MANDATORY**CAL-61-04****TITLE**

PROPELLER - B-40755A SPRAY HEAD ASSEMBLY REPLACEMENT

SERVICE BULLETIN

B-40755A SPRAY HEAD ASSEMBLY REPLACEMENT

Figure 1. TKS Spray Head Assembly (Sheet 1)

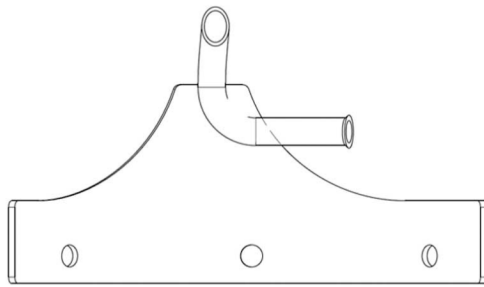
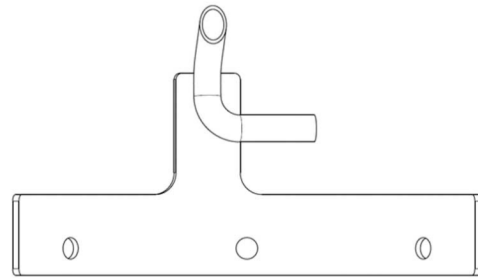
McCauley is introducing a new revision of the spray head assemblies installed as part of the C778 Caravan STC prop kit. Reports from the field indicate the rubber tubes that transfer TKS fluid from the slinger ring to the spray head nozzles can become separated from the spray head assemblies. The addition of a flare to the spray head assembly will help retain the rubber tube. The revised spray head assembly is identified as B-40755A, where the "A" that follows the part number identifies the new revision of the B-40755 part number. Failure to comply with this service letter could result in a total or partial loss of anti-icing capabilities of the aircraft propeller.

This service bulletin provides parts and instructions to replace the B-40755 Spray Head Assembly with the new B-40755A Spray Head Assembly.

NOTE: All spray head assemblies must be replaced to the new B-40755A assembly.
